AMENDMENTS TO THE DRAWINGS:

REMARKS

FIG. 1 - Prior Art

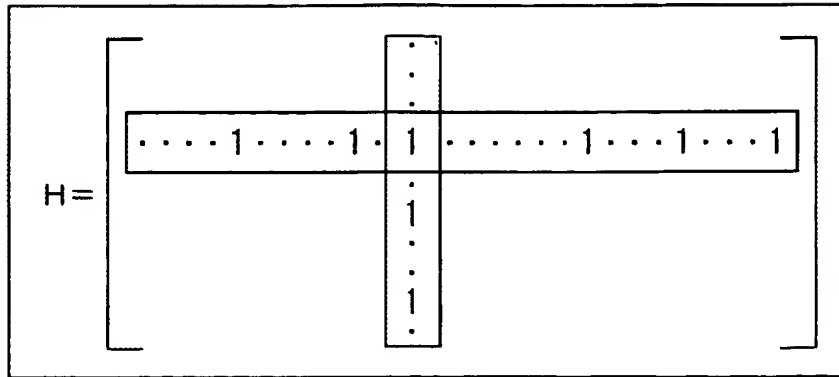
Applicants respectfully request reconsideration and withdrawal of the objection to the drawings. The drawings comply with 37 C.F.R. § 1.83(a) because Applicants have amended Figures 1-8 as suggested by the Examiner on page 2 of the outstanding Office Action. Specifically, Applicants have amended Figures 1-8 to include the label "Prior Art."
